भारत सरकार – रेल मंत्रालय  
 अनुसंधान अभिकल्प और मानक संगठन  
 लखनऊ – 226011  
 Government of India - Ministry of Railways  
 Research, Designs & Standards Organization,  
 LUCKNOW - 226011

**MODIFICATION SHEET NO. RDSO/2012/EL/MS/0413, Rev. '1' Dated 25.04.2016**

Paralleling of interlocks of EP contactors and auxiliary contactors of three phase locomotives to improve reliability.

MODIFIED SCHEMATIC POSITION : 12.3/1  
SR Precharging Contactor-1

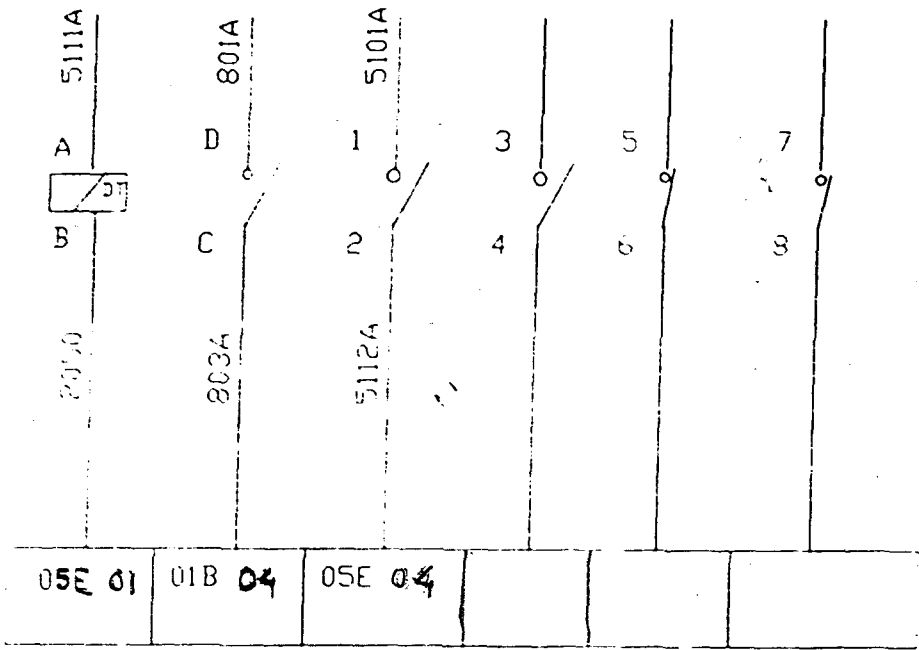
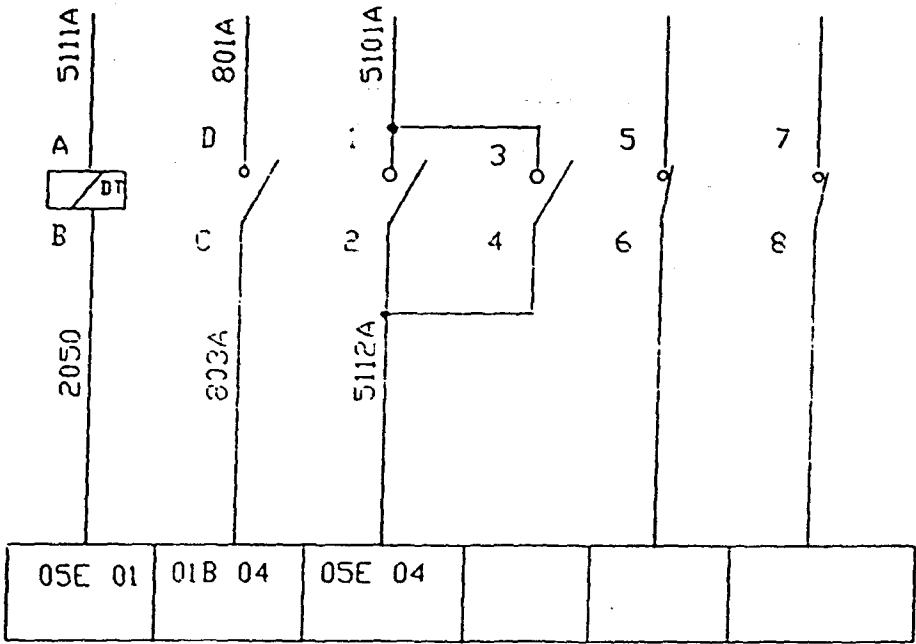
1.	12.3/1 & 2	SR Precharging contactor	0	01 NO	....	01 NO	SR Cubicle	In type LADN-22, the spare NO interlock 3-4 is to be paralleled with used NO interlock 1-2.

MODIFIED SCHEMATIC POSITION : 52/1  
AUXILIARY CONTACTOR

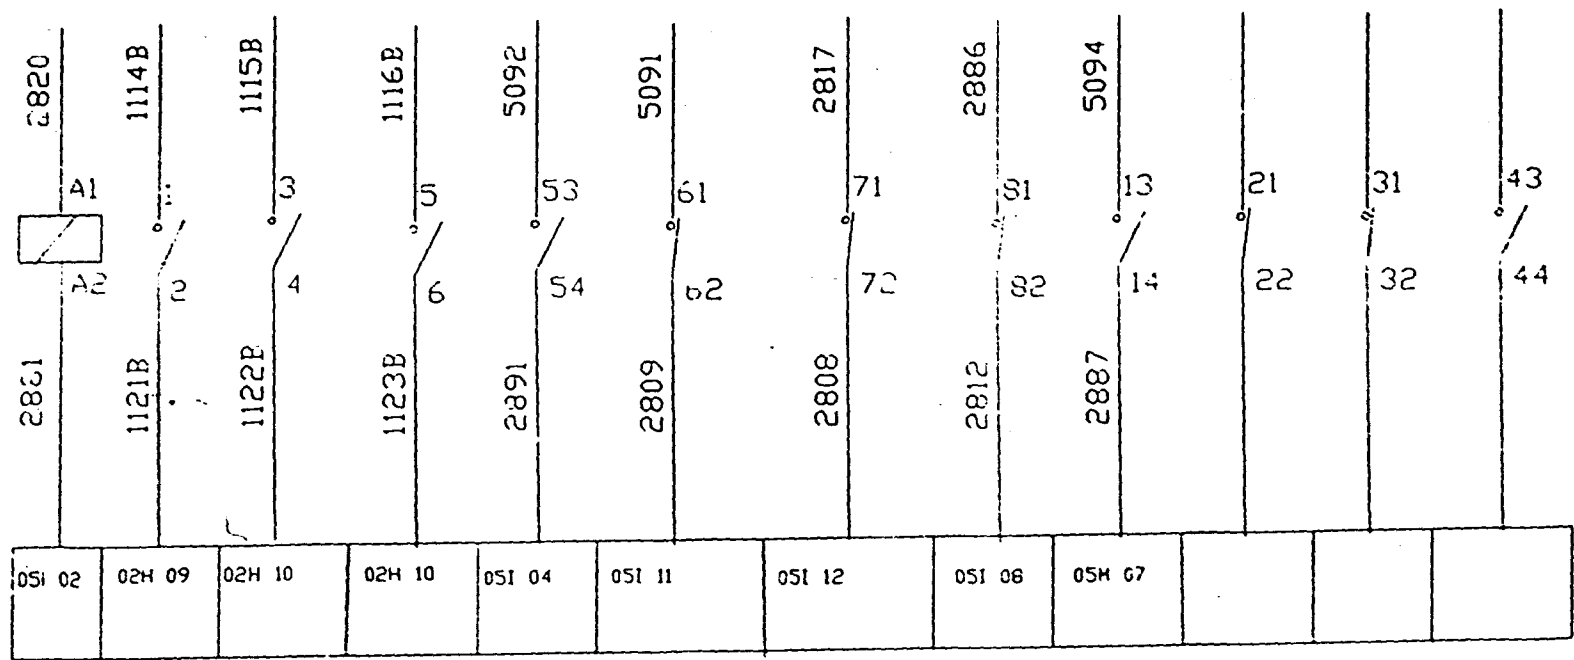
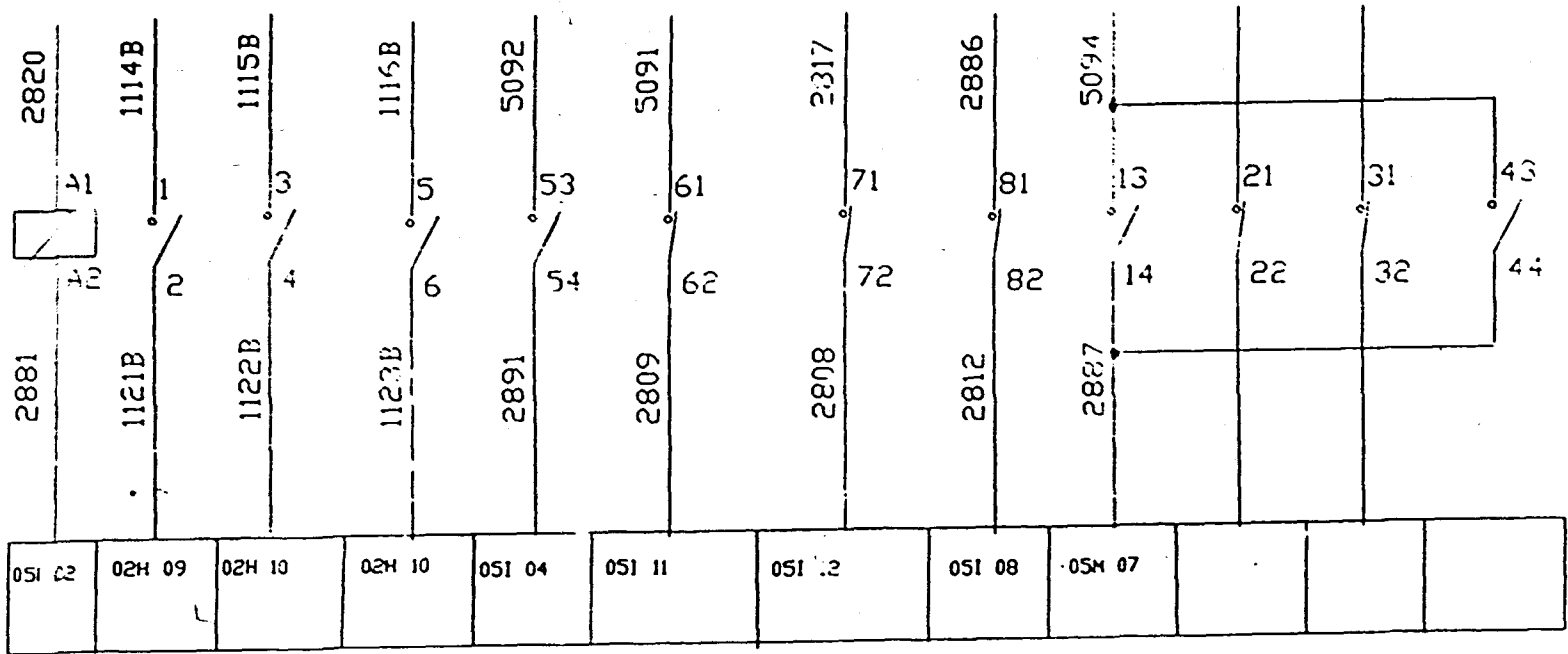
2.	52/1	Auxiliary Contactor	01 NO + 03 NC	01 NO	NIL	01 NO + 02 NC	BUR-2/3	In type LADN-22. The spare NO interlock 43-44 is to be paralleled with used NO interlock 13-14.

MODIFIED SCHEMATIC POSITION : 52/2  
AUXILIARY CONTACTOR

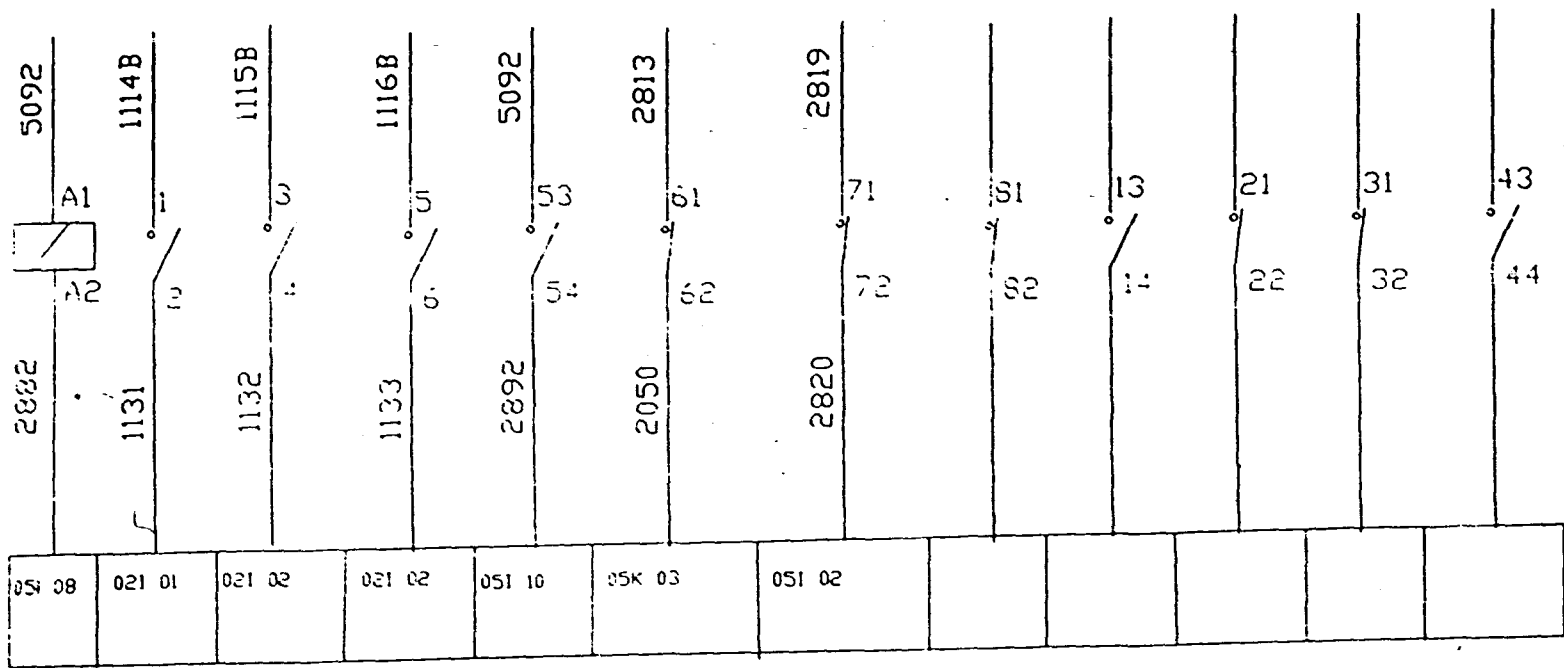
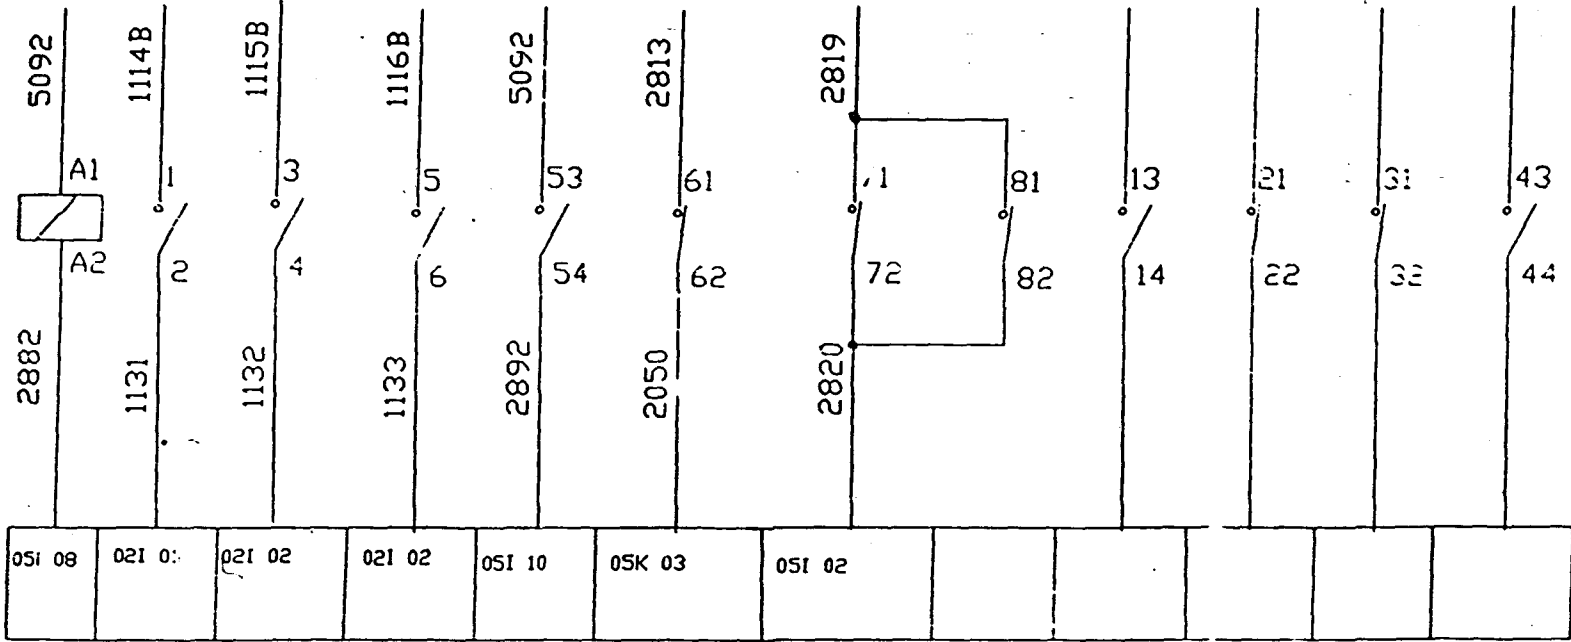
3.	52/2	Auxiliary Contactor	01 NO + 02 NC	Not in service	01 NC	Not in service	BUR-2/3	In type LADN-13. The spare NC interlock 81-82 is to be paralleled with used NO interlock 71-72.

MODIFIED SCHEMATIC POSITION : 52/3  
AUXILIARY CONTACTOR

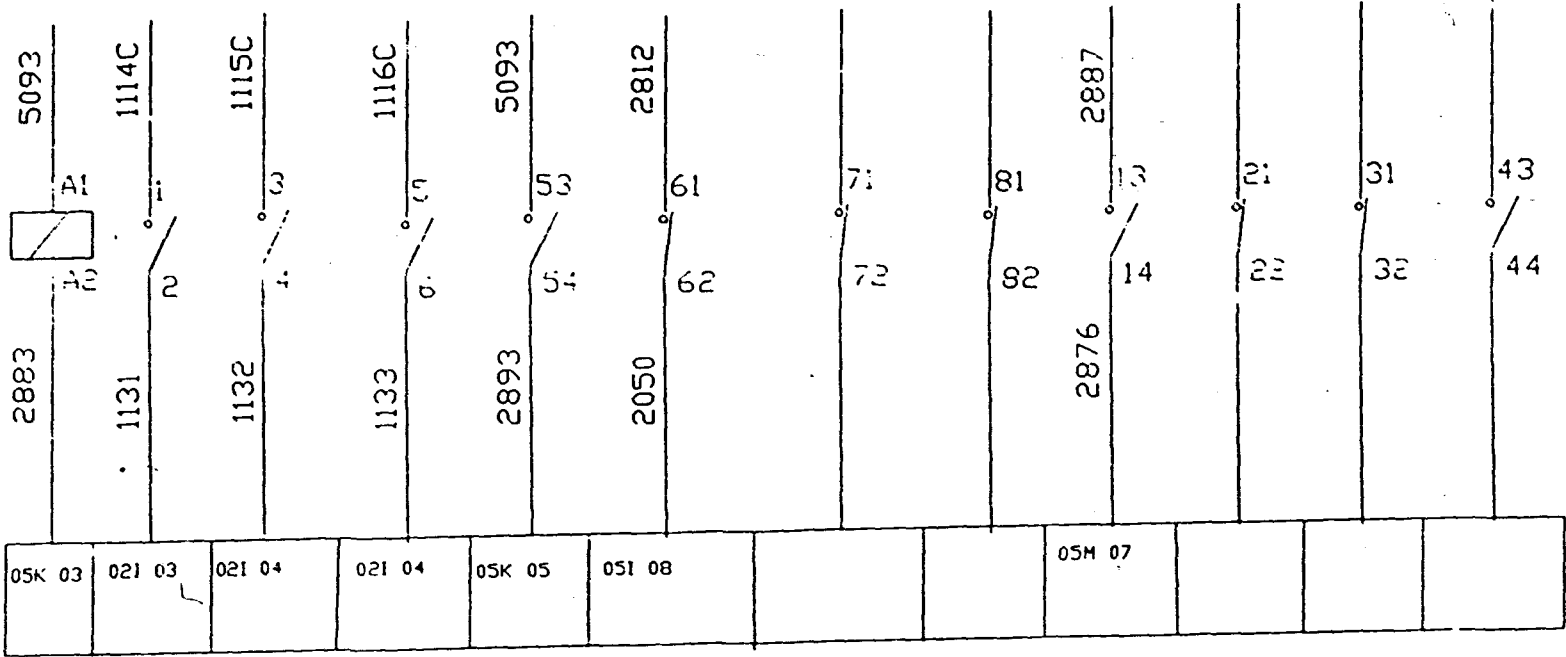
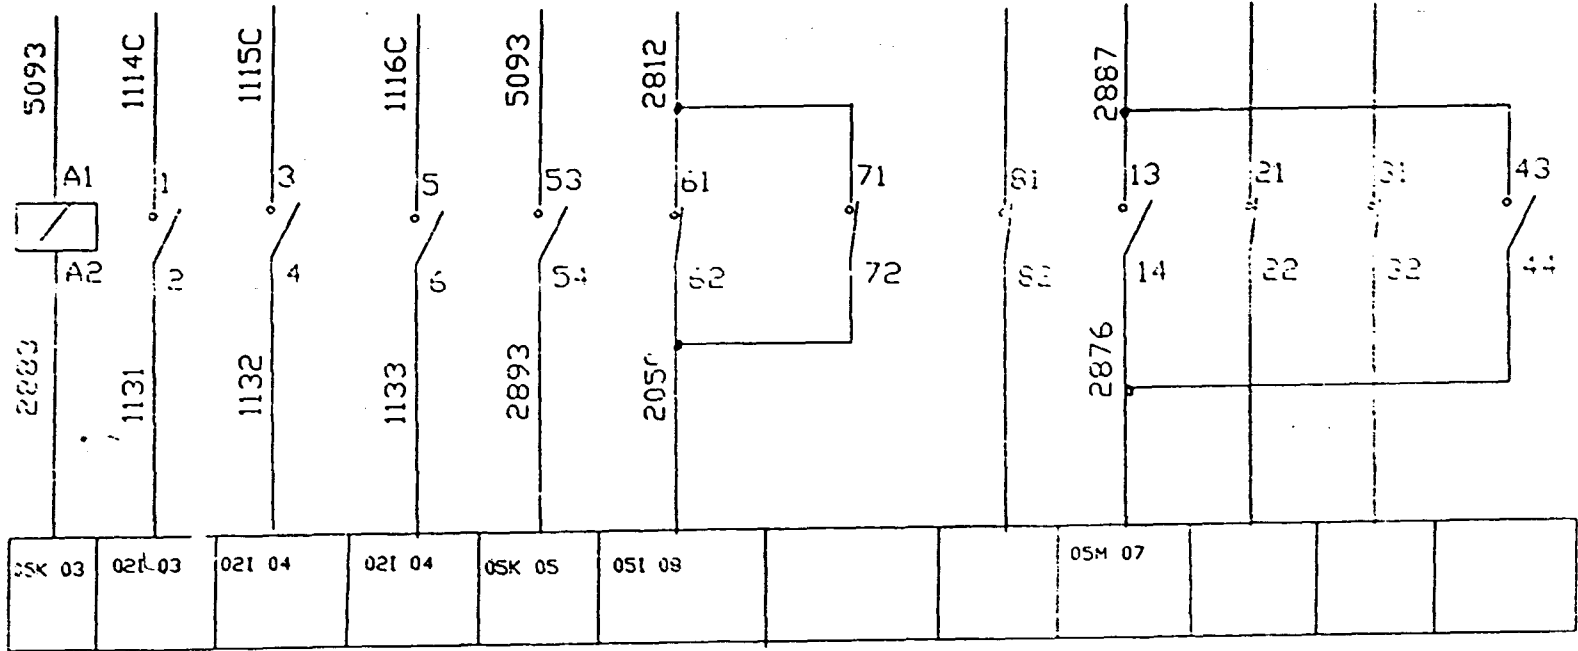
4.	52/3	Auxiliary Contactor	01 NO + 01 NC	02 NO	02 NC	02 NC	BUR-2/3	In type LADN-13 the spare NC I/L 71-72 is to be paralleled with use N/C I/L 61-62. In type LADN-22 the spare NO I/L 43-44 is to be paralleled with used NO I/L 13-14.

MODIFIED SCHEMATIC POSITION : 52/4  
AUXILIARY CONTACTOR

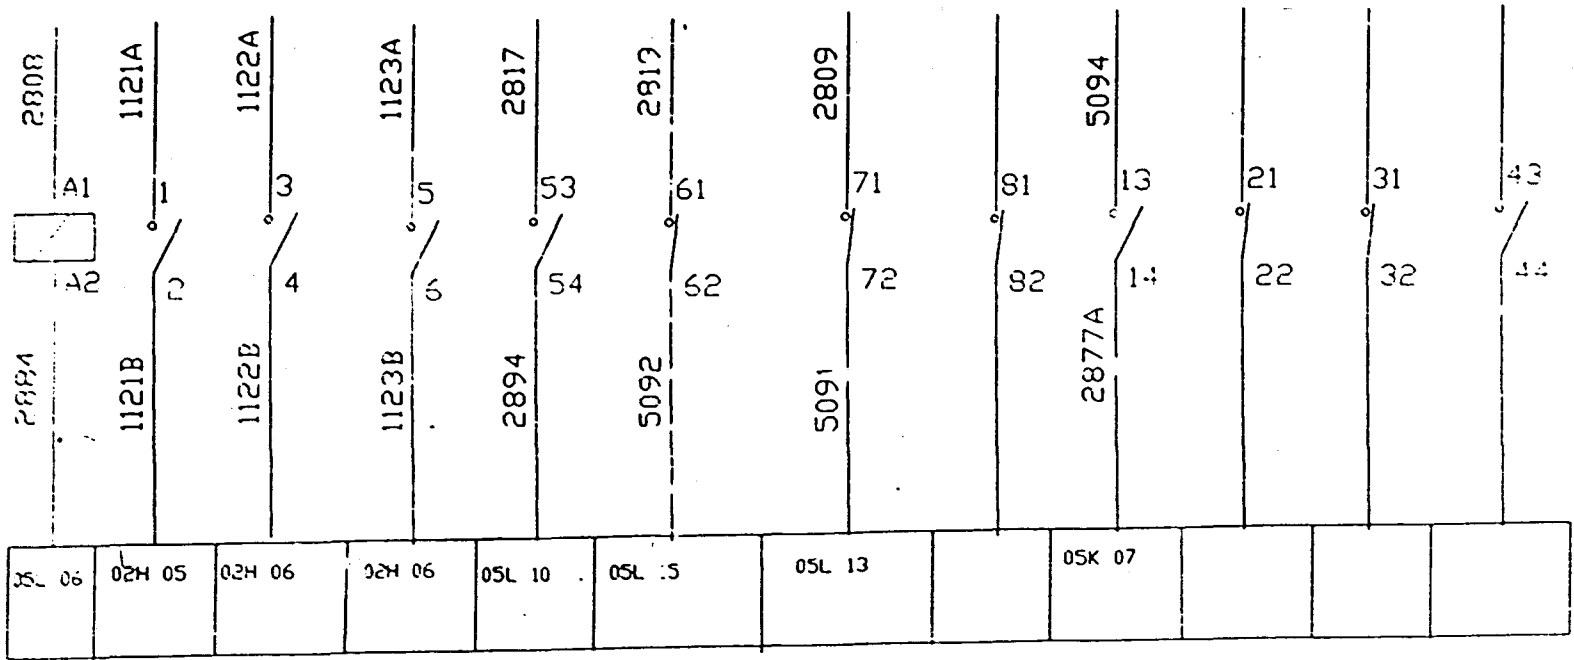
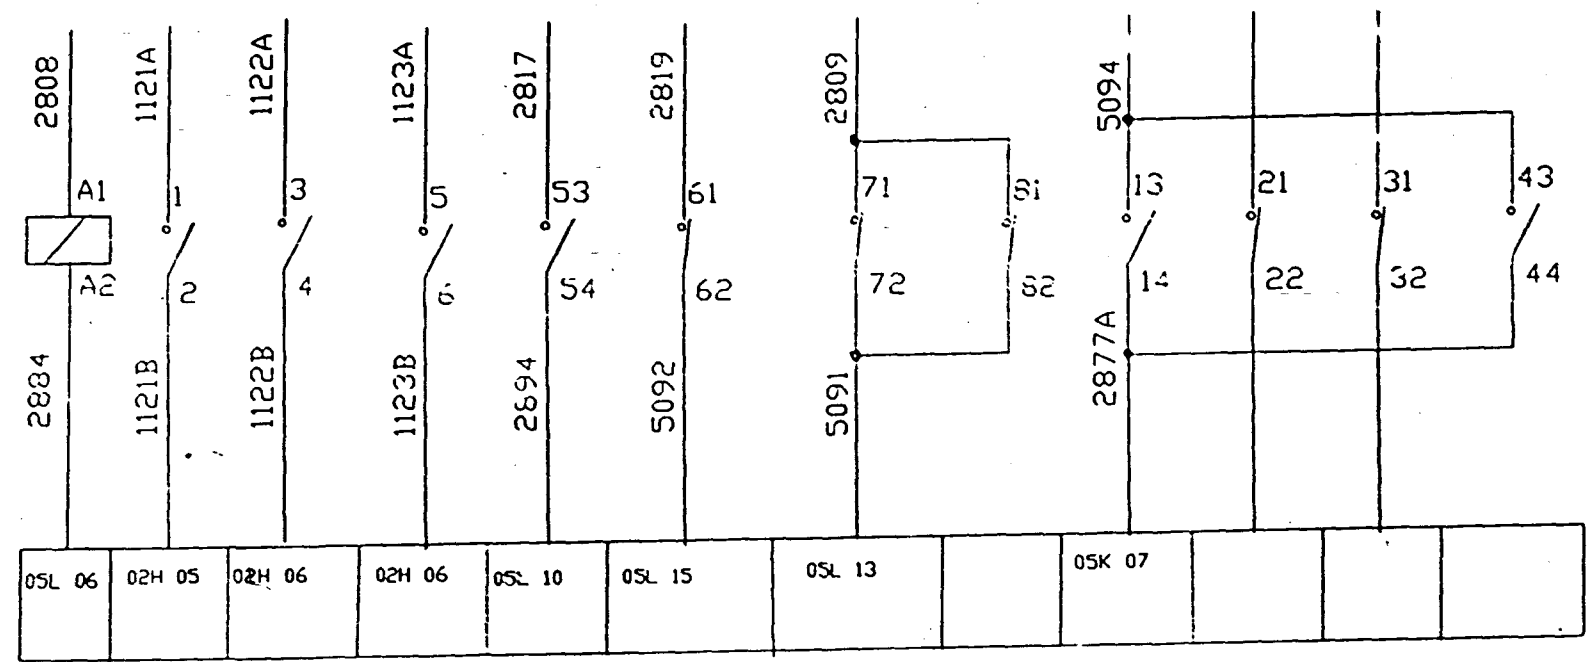
5.	52/4 & 52/5	Auxiliary Contactor	01 NO + 02 NC	01 NO	01 NC	01 NO + 02 NC	HB-1	In type LADN-13 the spare 81-82 NC I/L is to be paralleled with used NC I/L 71-72. In type LADN-22 the spare NO I/L 43-44 is to be
